**Fieldhouse HVAC Replacement
NAU Project #09.300.251
Hard Bid Procurement for Construction
Services April 29, 2026**

ADDENDUM #1

AIR HANDLING UNIT (AHU) SUBMITTAL PACKAGE

Unit Layout

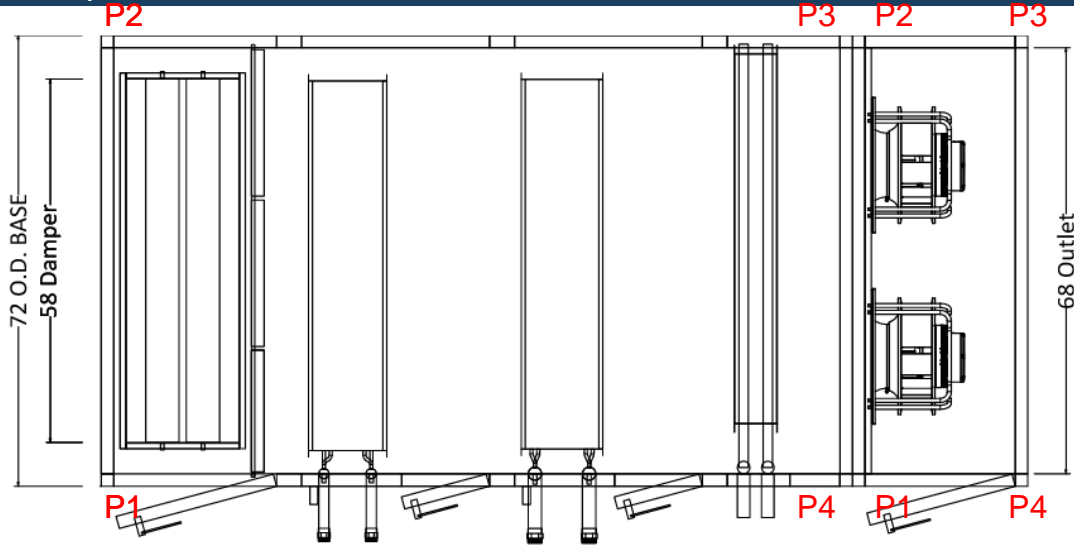
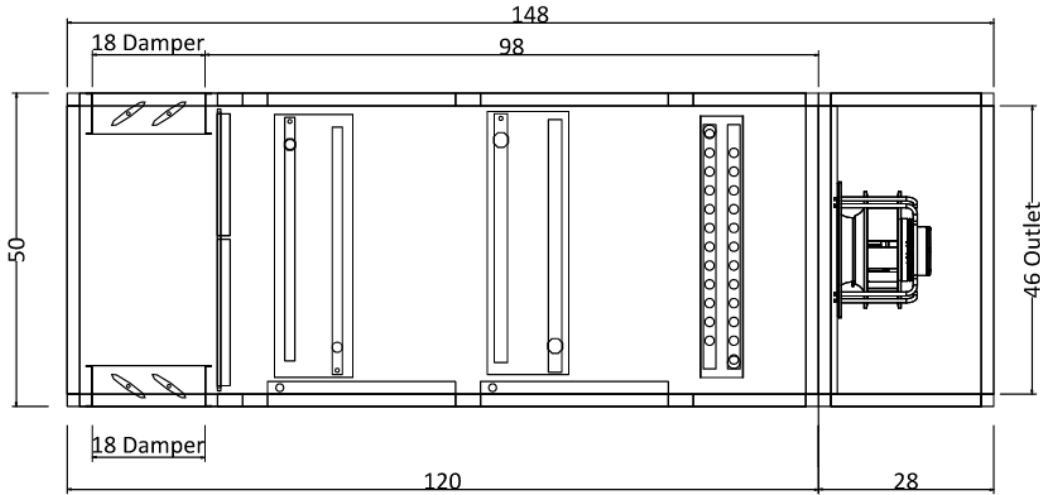
A	APPROVED			
	B	NOTATIONS, NO RESUBMITTAL (REFER TO NOTATIONS)		
		C	REVISE & RESUBMIT (REFER TO NOTATIONS)	
			F	REJECTED (REFER TO NOTATIONS)
			NS	NOT SUBMITTED
				ITEM
				NOTATIONS
	B			FH-1,2; HV-1
				Contractor to confirm handing.
